Business TeleCommunications (BTC); 64 kbit/s digital unrestricted leased line with octet integrity (D64U); Network interface presentation

AMENDMENT

ETS 300 288

**This amendment A1 modifies
the European Telecommunication Standard ETS 300 288 (1994)**

iTeh STANDARD PREVIEW
(standards.iteh.ai)
Figure 1

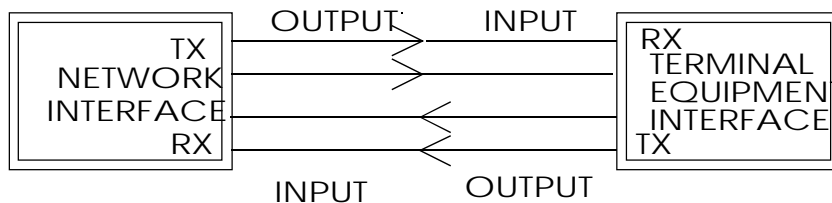
Page 9, amendment to subclause 5.1

Replace subclause 5.1 and its subclauses with subclauses 5.1, 5.1.1, 5.1.2 and 5.1.3 as given below:

The transmit pair is the output from the network interface. The receive pair is the input to the network interface, as shown in figure 1. Where the terms "output" and "input" are used without qualification in this ETS, they refer to the network interface.

The connection arrangements provided by the leased line interface shall be suitable for hardwired connection (see subclause 5.1.1). However, with the agreement of the user, an alternative means of connection, using a socket, may be provided (see subclause 5.1.2).
